161st Street and Carey Road Roundabout Vectren Gas Utility Reimbursement Agreement

VECTREN REIMBURSEMENT AGREEMENT

**VECTREN ENERGY
RELOCATION DRAWING**

PLAN AND PROFILE
LINE "PR-A" STA. 21+00 TO 26+00

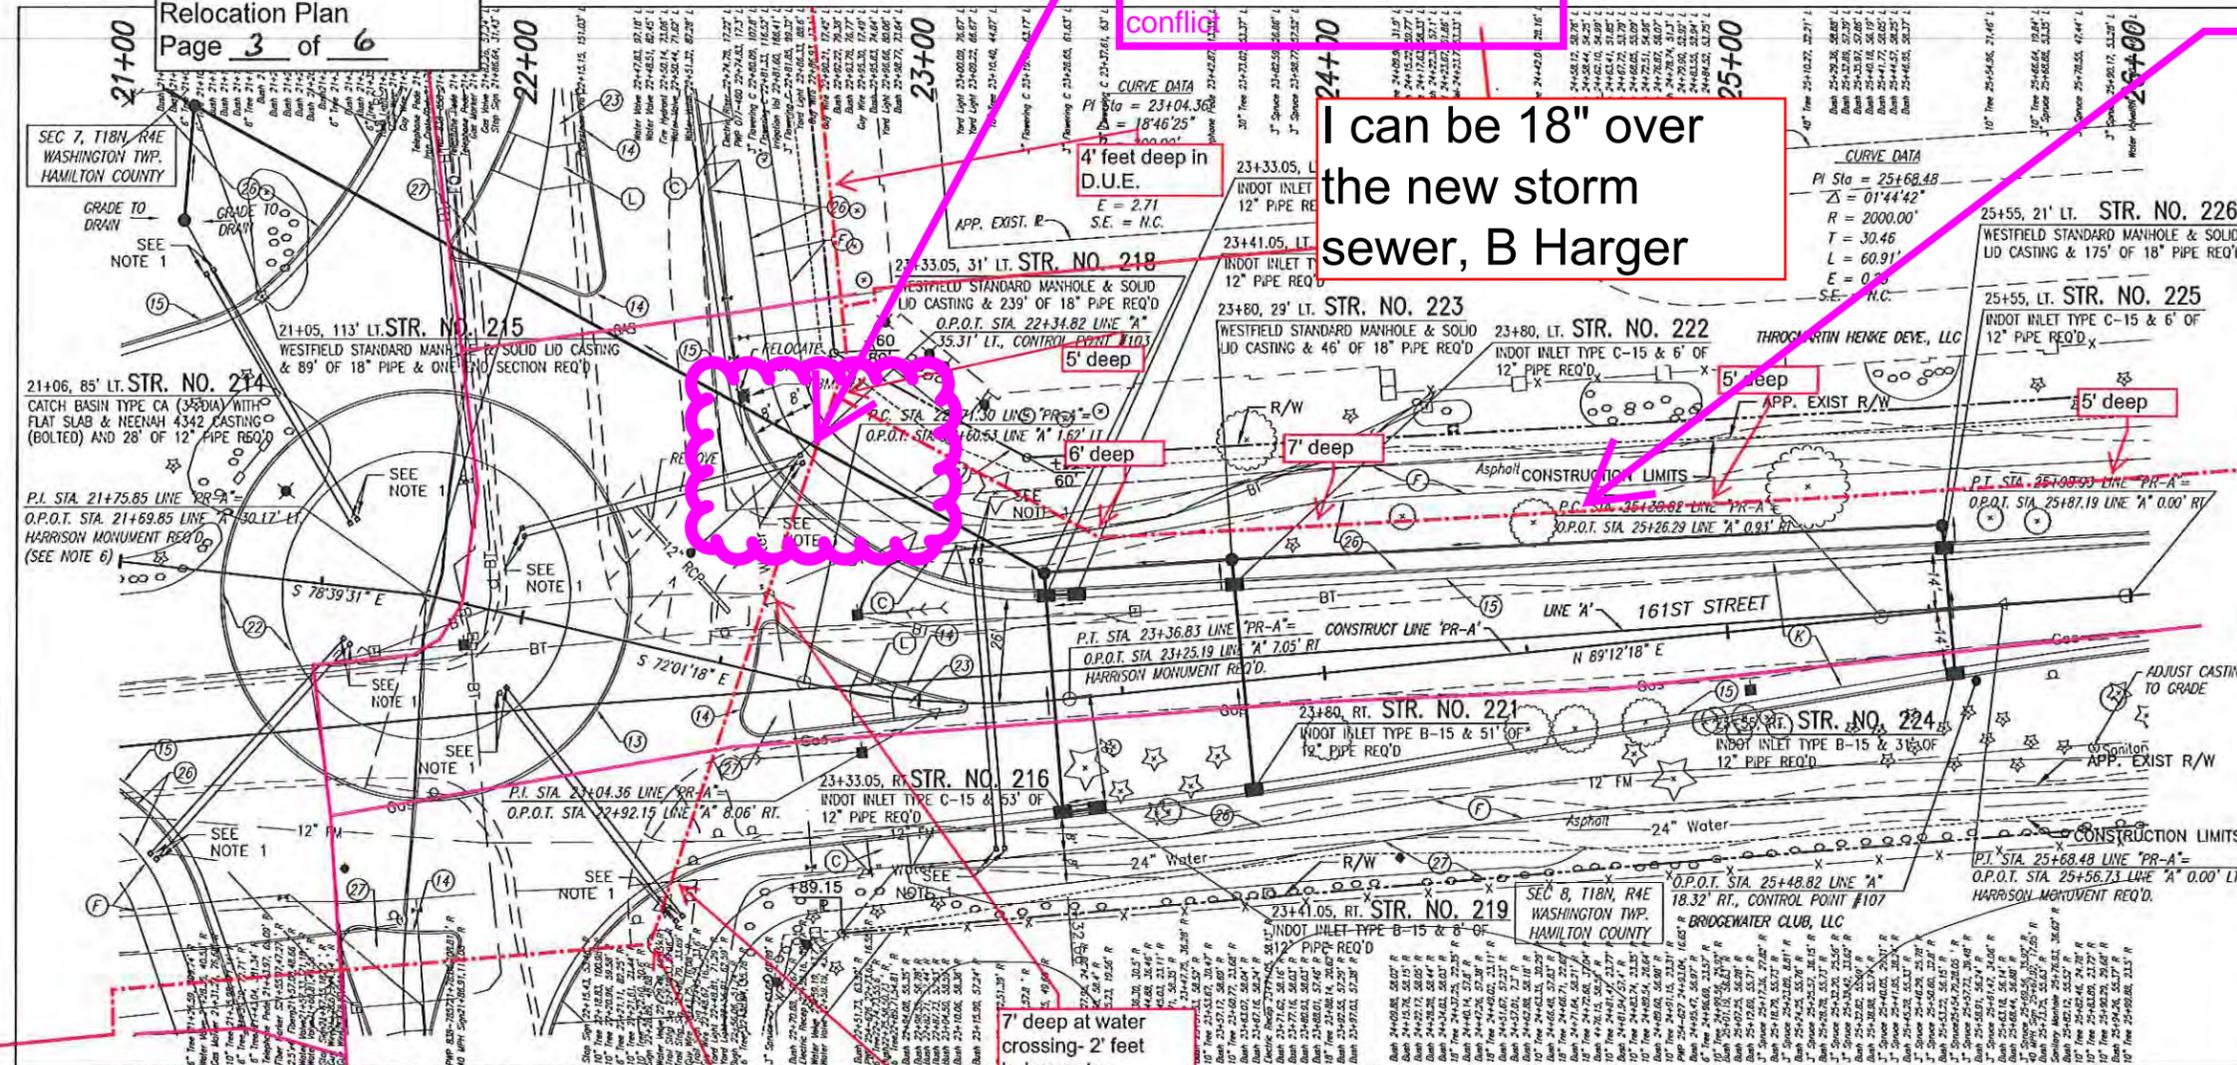
Proposed Storm
Elevation=848.50-Check
conflict

Gas line needs to be at 35'
offset from existing center
of the road to avoid new
Storm

I can be 18" over
the new storm
sewer, B Harger

35' will be okay-
B Harger

PLAN AND PROFILE
LINE "PR-A" STA. 26+00 TO 31+00

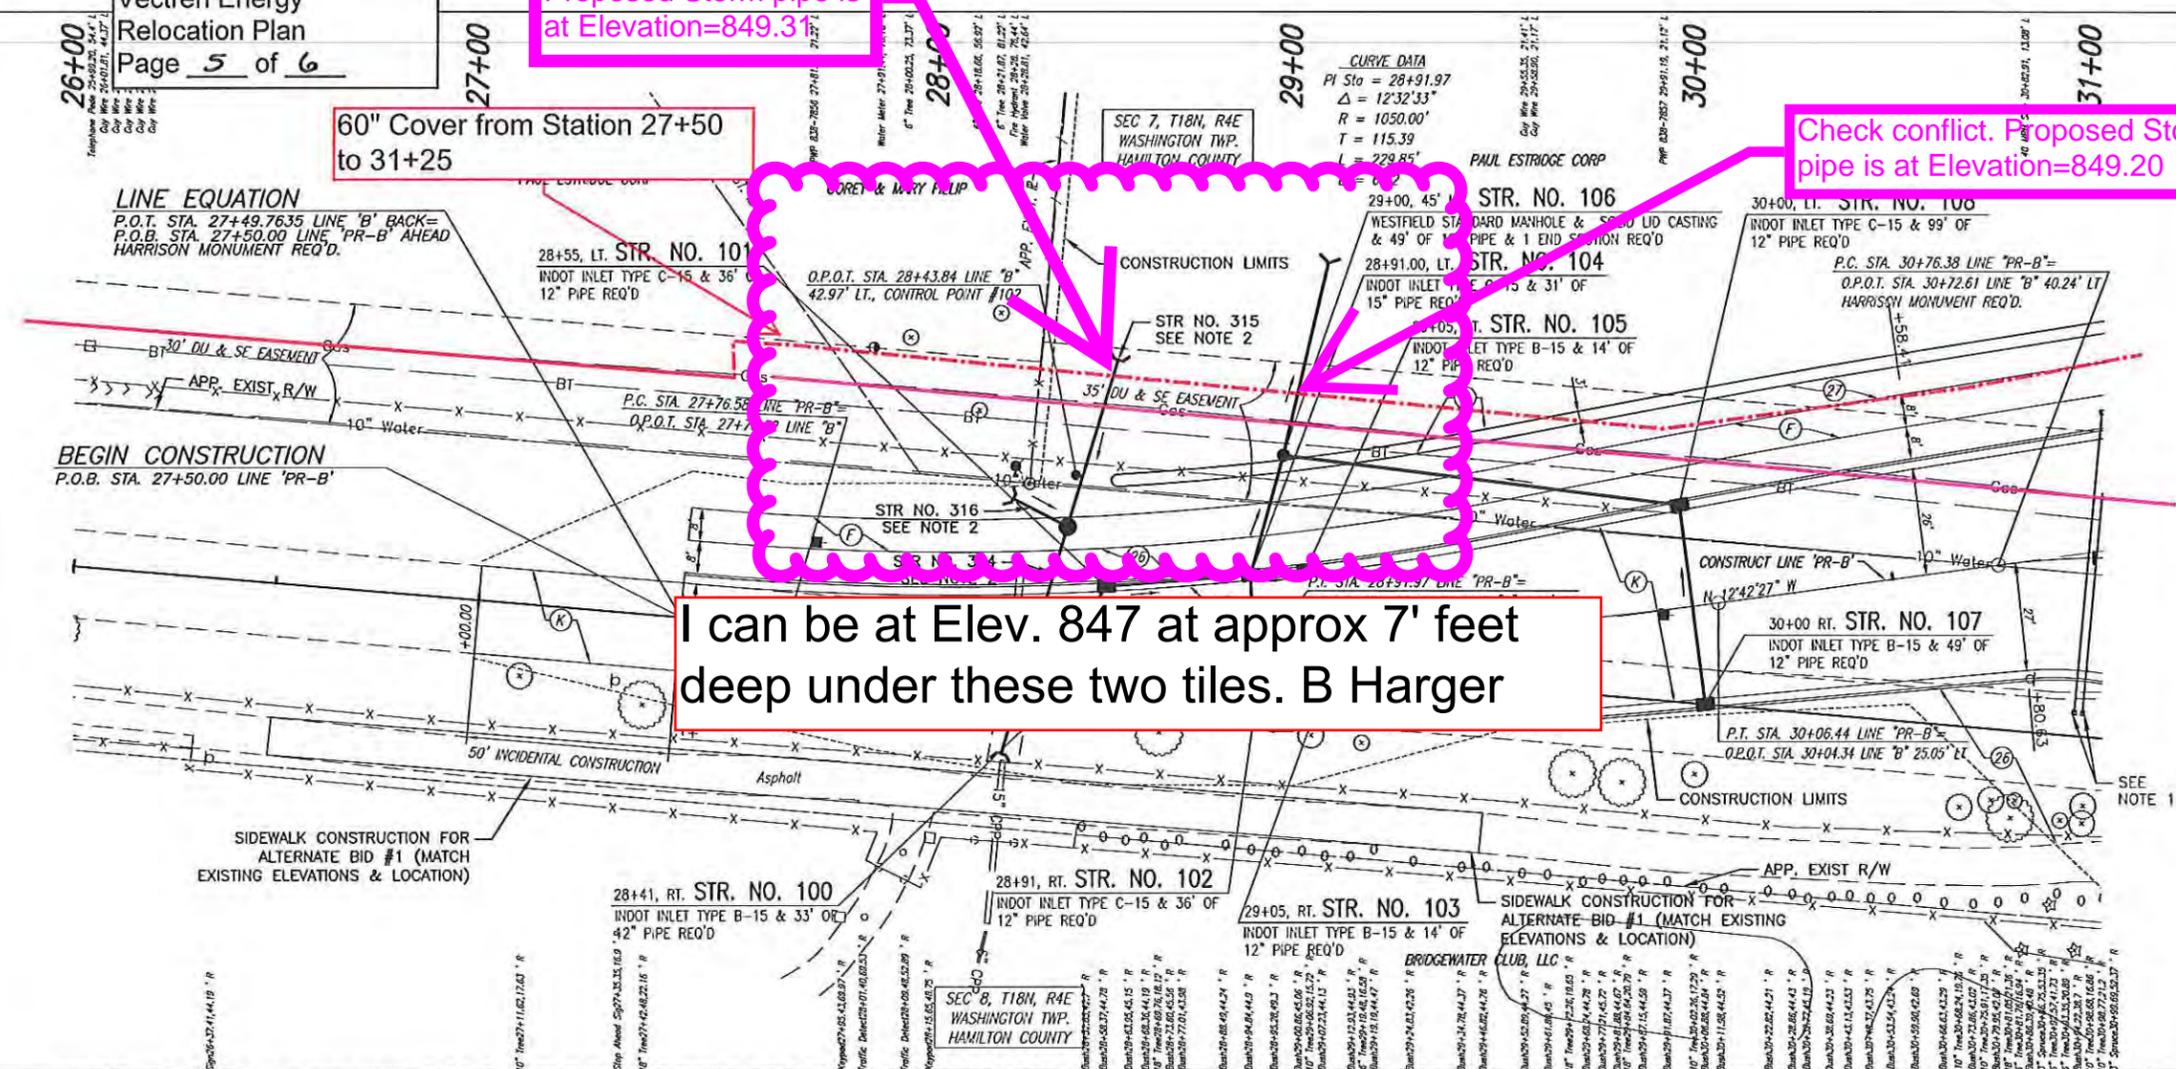
Check conflict.
Proposed Storm pipe is
at Elevation=849.31

60" Cover from Station 27+50
to 31+25

Check conflict. Proposed Storm
pipe is at Elevation=849.20

I can be at Elev. 847 at approx 7' feet
deep under these two tiles. B Harger
